Braidwood Station, Units 1 and 2
Facility Operating License Nos. NPF-72 and NPF-77
NRC Docket Nos. STN 50-456 and STN 50-457

Byron Station, Units 1 and 2
Facility Operating License Nos. NPF-37 and NPF-66
NRC Docket Nos. STN 50-454 and STN 50-455

Subject: Responses to NRC Requests for Additional Information, Sets 33 and 34, both dated June 23, 2014; and Corrections and Clarifications related to the Byron Station, Units 1 and 2, and Braidwood Station, Units 1 and 2, License Renewal Application

Enclosure A
Byron and Braidwood Stations (BBS), Units 1 and 2
License Renewal Application

Figure 1 – Soil Corrosion (SC) Probe Simplified Drawing

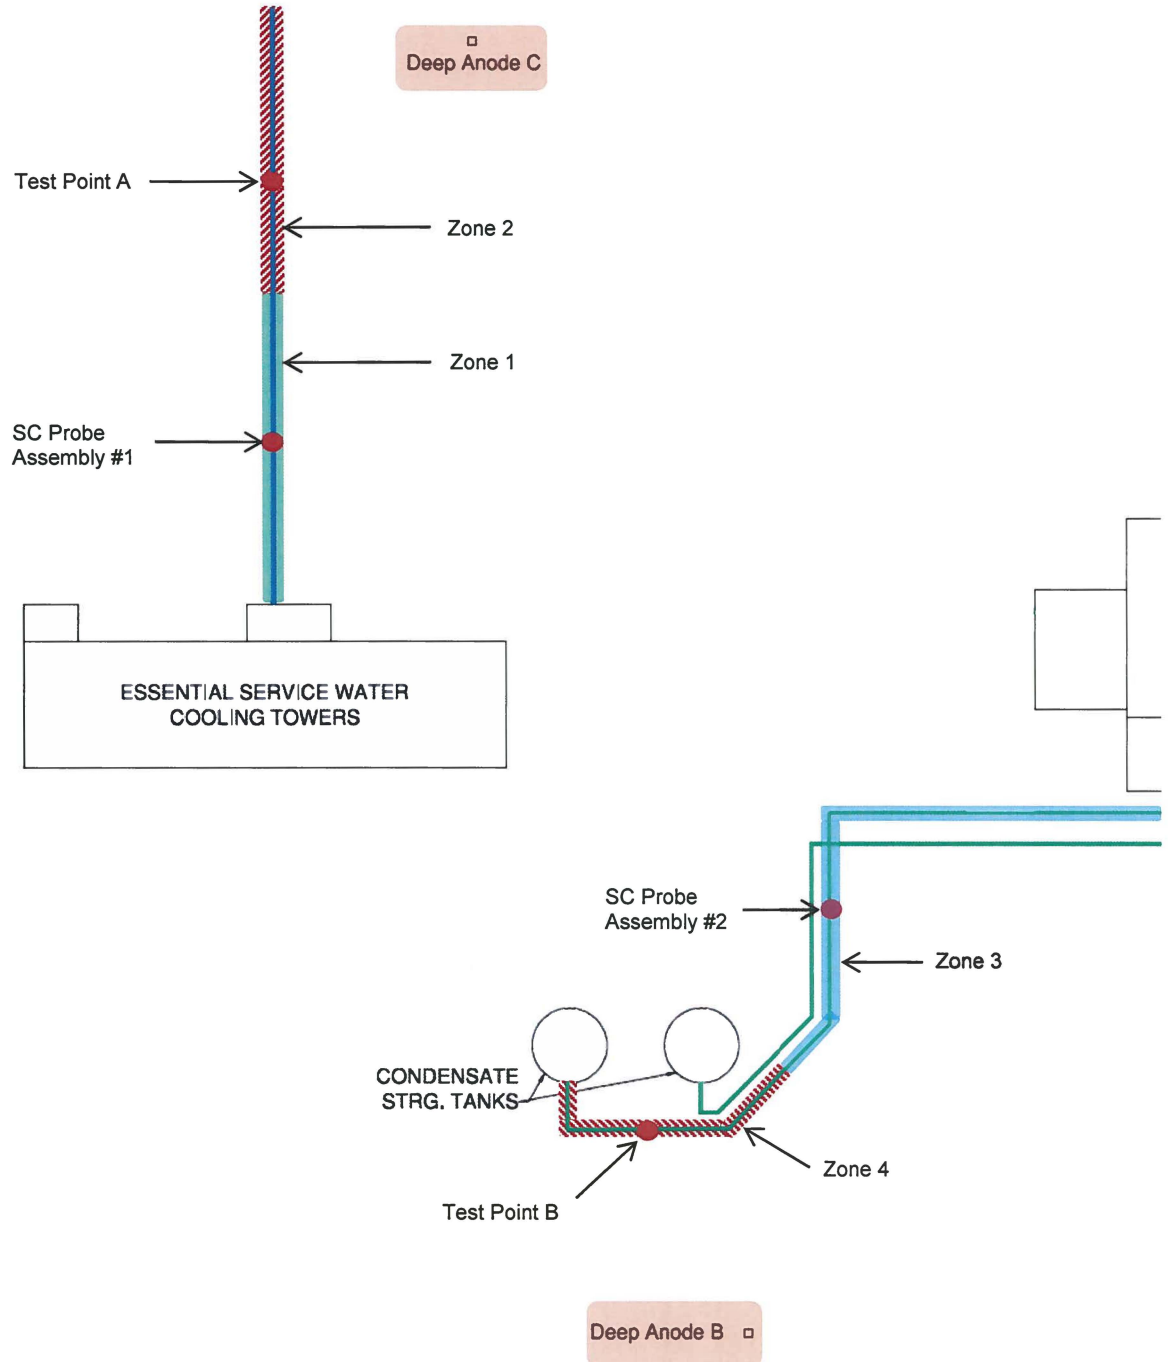
- c. Based on its review of the response to RAI B.2.1.28-3a, the staff understands that a soil corrosion probe could be used to verify that effective cathodic protection has been provided to pipe segment locations remote from the probe. The staff has the following concerns:

- i. A NACE qualified cathodic protection expert will evaluate the impact of significant site features as they could affect cathodic protection effectiveness. However, the response did not state the factors that will be considered when evaluating the impact of local site features.

- ii. The response did not state how local soil conditions (e.g., moisture content, pH, and resistivity) could be impactful. For example, if the soil in the vicinity of the soil corrosion probe were less corrosive than at other pipe segment locations, the soil corrosion probe could under-predict the corrosion rate at other points of interest along the pipe length.

1. State:
 - a. the level of NACE cathodic protection qualification of the individuals involved in selecting soil corrosion probe locations and for determining the impact of localized site features
 - b. Whether soil corrosion probes will be installed in close proximity to the buried piping of interest, or state the basis for its location if installed remotely from the pipe of interest.
 - c. What factors will be considered when evaluating local site features including examples of how the factors would be applied.
 - d. How local soil conditions will be factored into use of the soil corrosion probe data.

In order to further explain the intended use of the soil corrosion probe assemblies with respect to the areas in which they may be used to assess cathodic protection effectiveness, provided below are example scenarios involving Figure 1 contained at the end of this RAI response.

Scenario 1:

- Prior to installation of new SC Probe assembly #1, existing conventional Test Point A would represent CP effectiveness for Zone 1 and Zone 2 for the buried pipe of interest.

- After installation of new SC Probe assembly #1, electrically connected to and physically located in close proximity to the same buried pipe of interest as Test Point A, SC Probe assembly #1 will assess CP effectiveness for Zone 1, and Test Point A will assess CP effectiveness for Zone 2.

- If Test Point A fails to meet -850mV, Zone 2 may still be considered adequately protected based upon a satisfactory reading for SC Probe assembly #1 because:

- SC Probe assembly #1 is located further from Deep Anode C than Test Point A.
 - No exposed metallic site features are located near Test Point A which could serve as large current collectors or otherwise shield current from reaching the buried pipe to which Test Point A is connected.

- Use of SC Probe assembly #1 to assess Zone 1 and Zone 2 is consistent with the previous practice prior to its installation when Test Point A represented both Zones.

Therefore, data from SC Probe assembly #1 may be used to assess CP effectiveness along the lengths represented by Test Point A.

Scenario 2:

- Prior to installation of new SC Probe assembly #2, existing conventional Test Point B would represent CP effectiveness for Zone 3 and Zone 4 for the buried pipe of interest.
- After installation of new SC Probe assembly #2, electrically connected to and physically located in close proximity to the same buried pipe of interest as Test Point B, SC Probe assembly #2 will assess CP effectiveness for Zone 3, and Test Point B will assess CP effectiveness for Zone 4.
- SC Probe assembly #2 is located further from Deep Anode B than Test Point B.
- Test Point B is located in close proximity to 2 tanks with uncoated metallic tank bottoms founded directly on grade. These tanks may behave as current collectors, resulting in potentially less available current in the vicinity of the adjacent buried pipe of interest, and subsequently lower polarization values at the location of Test Point B.

Therefore, data from SC Probe assembly #2 will NOT be used to assess CP effectiveness in the areas represented by Test Point B.
